Deltair Pressure Transducer Replacement

P/N: 025562

**Caution: Avon Protection requires replacement of the identified pressure transducer as detailed on this bulletin at the earliest possible date. During cold temperature operation the transducer may give an inaccurate pressure signal indicating the cylinder pressure is higher than actual. This may also prevent the electronics from being shut down after system pressure has been reduced to ambient.**

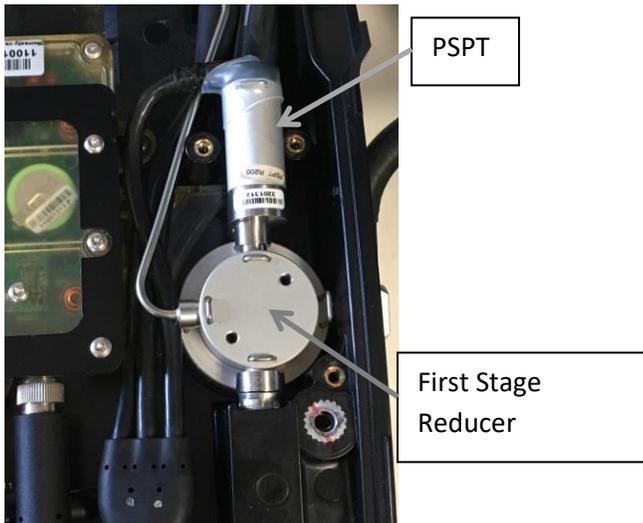
Avon Protection has become aware of a potential issue regarding the PSPT, Power Saving Pressure Transducer, identified in the photo below (inside backframe, cover removed).

In some cases of cold temperature operation, and due to a defective pressure transducer lot from our supplier, the system may give an inaccurate pressure signal indicating the cylinder pressure is

higher than actual. This may also prevent the system electronics from being shut down after the system pressure has been vented and returned to ambient.

You are receiving this technical bulletin because your organization has been identified as a possible recipient of SCBA incorporating these pressure transducers. Avon Protection requires replacement of the pressure transducer at the earliest possible date, of any SCBA identified with affected transducers.

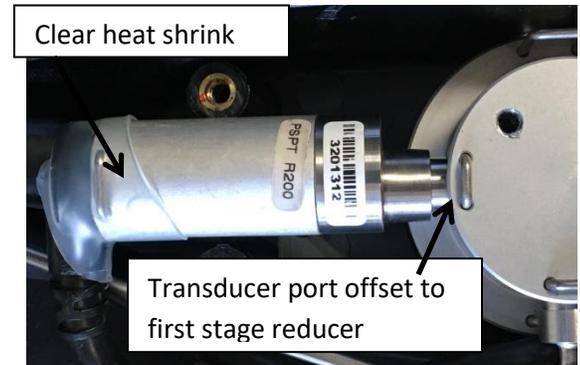
7. Remove short u-clip and remove old transducer from first stage reducer. Keep separate for return to Avon.
8. Verify the o-ring and white backup washer are situated inside the first stage reducer then insert the new pressure transducer into the port. Secure with the high pressure u-

clip. Verify offset orientation of transducer to first stage reducer with image shown in Step 12.

9. Apply dielectric grease lightly across cable connector face.
10. Align cable connector to new pressure transducer pins and insert fully into transducer housing. Compress slightly and fully insert the u-clip. Do not use excessive force, but do ensure the u-clip is fully seated.
11. Record serial number information on form.
12. Cut a piece of the clear heat shrink approximately 1” long and place over the u-clip connection, then use the heat gun to shrink. Use only enough heat to get the job done. Apply the heat evenly and do not overheat.
